INSTRUCTION TO SERVICE ITS: 3456

OBJECTIVE/SUBJECT:
Change Power Steering Line NF PN 323026

NOTE: THIS ITS IS TO BE DONE IN CONJUCTION WITH OR AFTER ITS 3419 IS PERFORMED

Figure 1: Bracket Removal

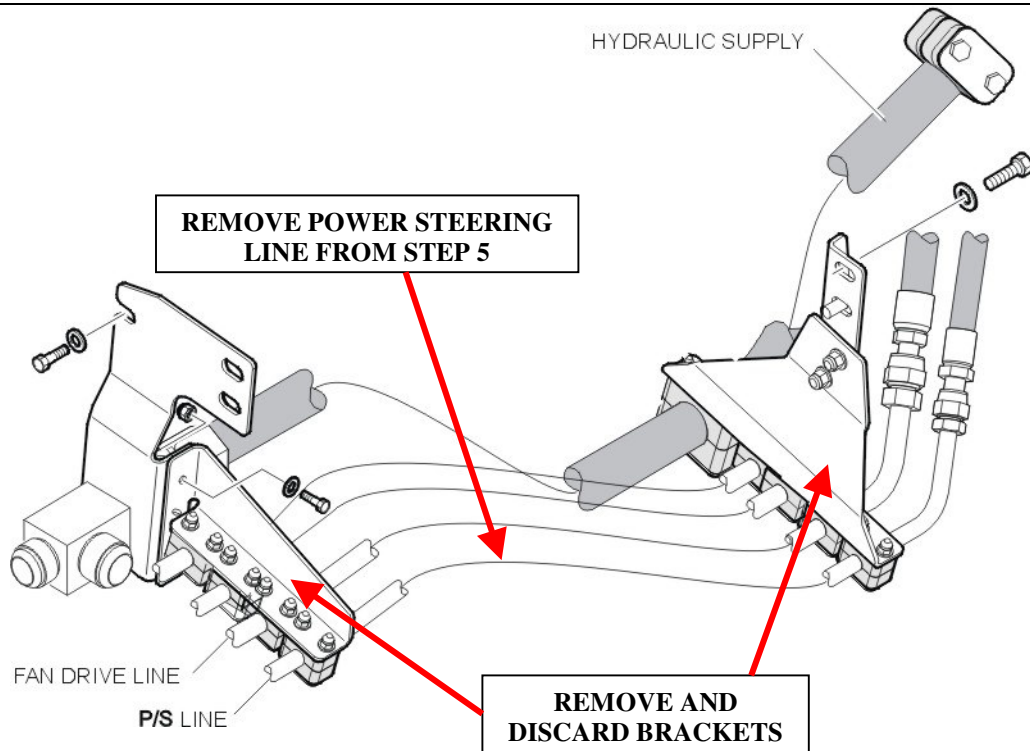
4. Undo stauff clamps retaining the power steering, hydraulic fan and oil cooler lines.
5. Disconnect the existing power steering line and the attached line that runs to the hydraulic manifold. Use caps to ensure manifold does not get contaminated with dirt.
6. Remove the brackets shown in Figure 1.

Figure 2: Bracket Installations

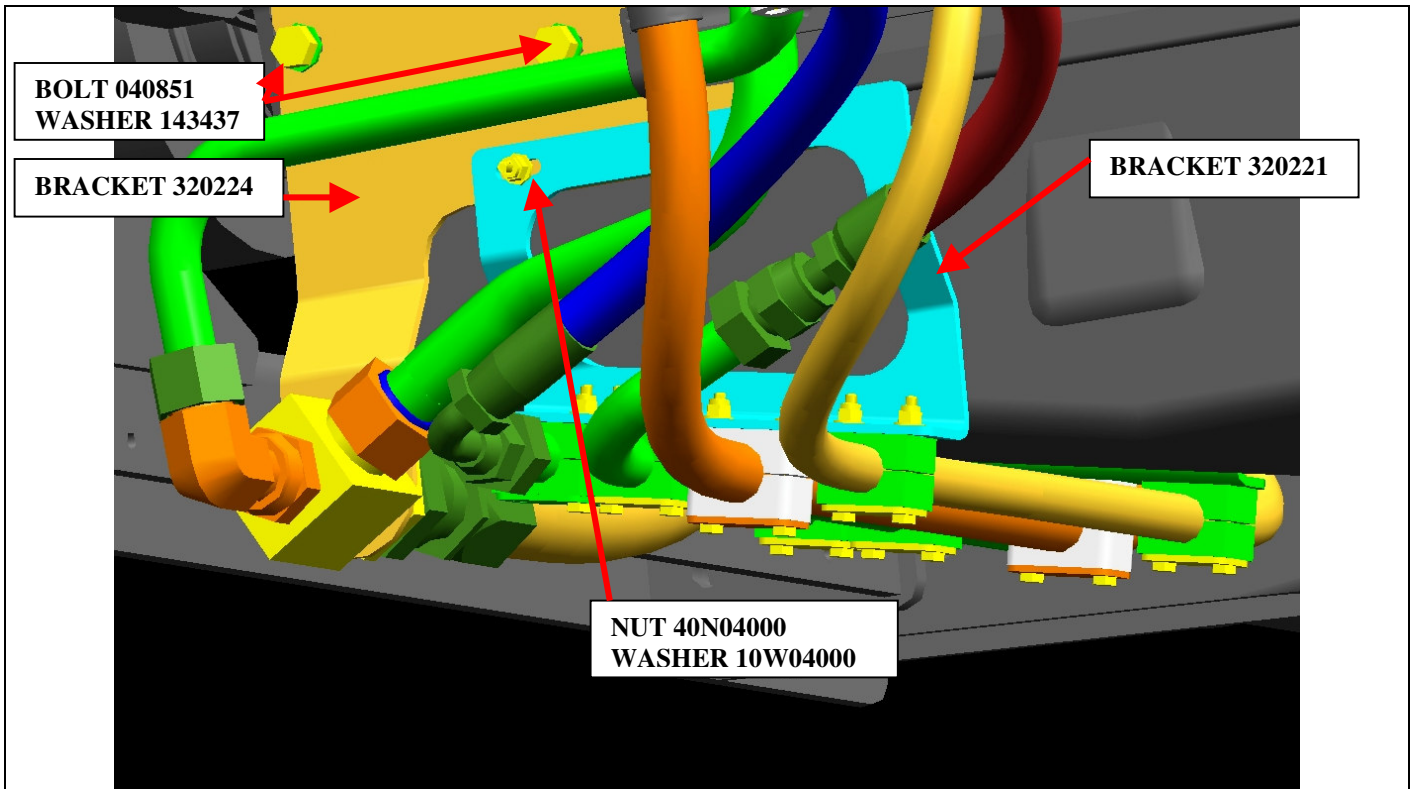
7. Insert the new hydraulic P/S tube bracket (NF PN 320224) in place of the removed bracket and install using M12 bolts (NF PN 040851) and M12 washers (NF PN 143437).
8. Install the new hydraulic tubes mounting bracket (NF PN 320221) and install using Hex lock nuts (NF PN 40N04000) and washers (NF PN 10W04000).
9. Install the hydraulic P/S lines mounting bracket (NF PN 320222) using bolt (NF PN 10B06016), washers (NF PN 10W06000) and nuts (NF PN 40N06000).

Figure 3: P/S Lines Bracket

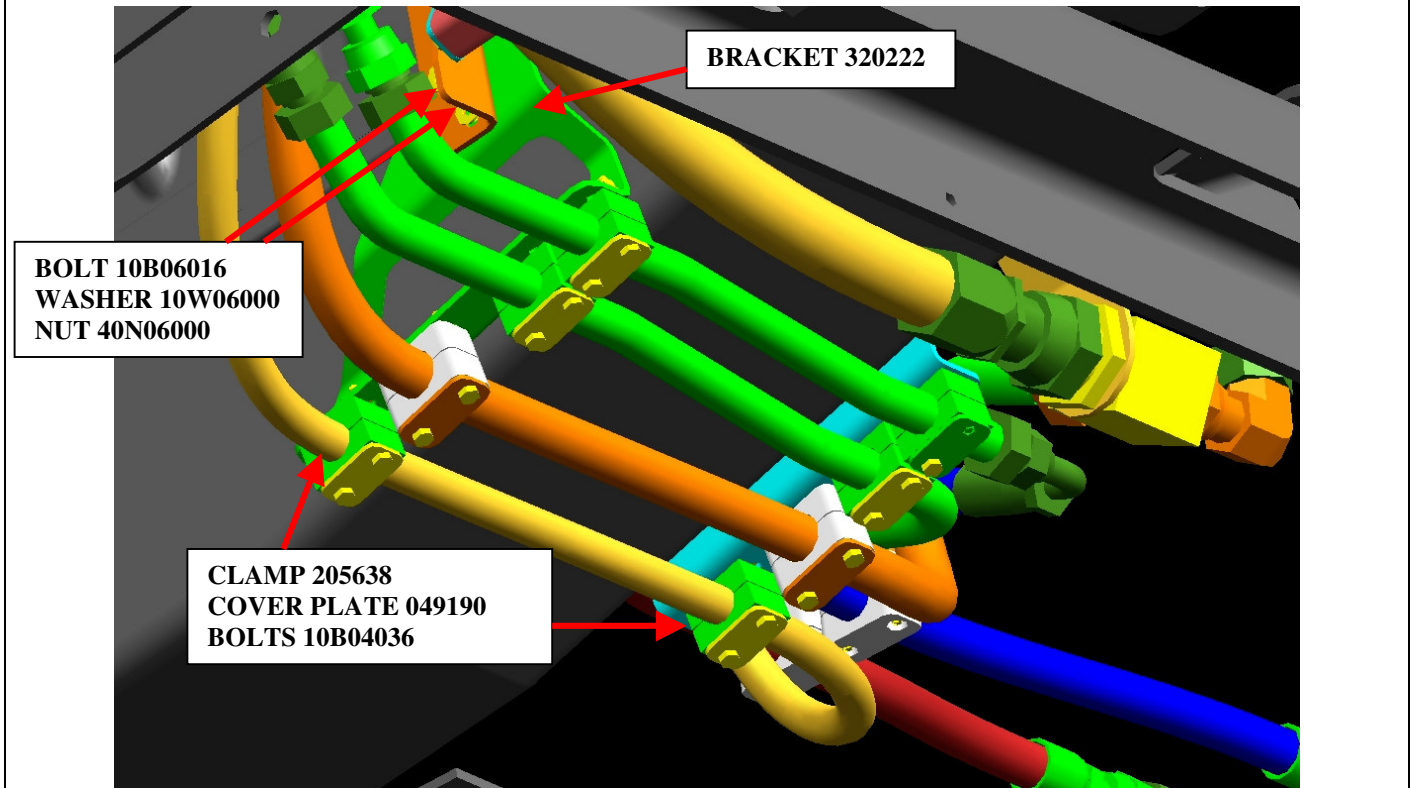
12. Insert the staff clamps and hardware for the P/S line as shown in the Figure 3 above.
13. Close the rear engine access door.
14. If necessary, lower coach in accordance with the New Flyer Service Manual.
15. Turn the main battery disconnect switch to the "ON" position.

Figure 4: P/S Line Installation (Pump View)

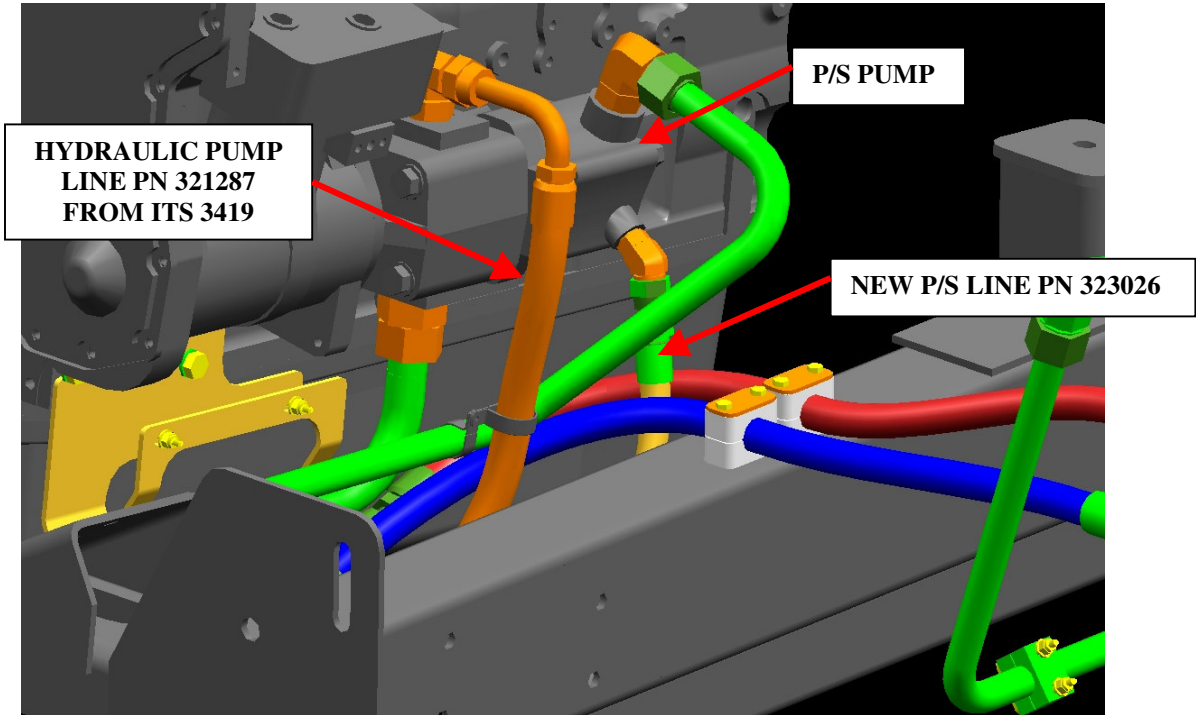
10. Reattach the stauff clamps to the oil cooler lines and to the hydraulic line (NF PN 321287).
11. Install the new power steering line (NF PN 323026) from the power steering pump to the hydraulic manifold. Use the Figures 4-6 as guidance for the installation.

NOTE: Torque P/S Line (NF PN 323026) to 46-50 Lbs-Ft
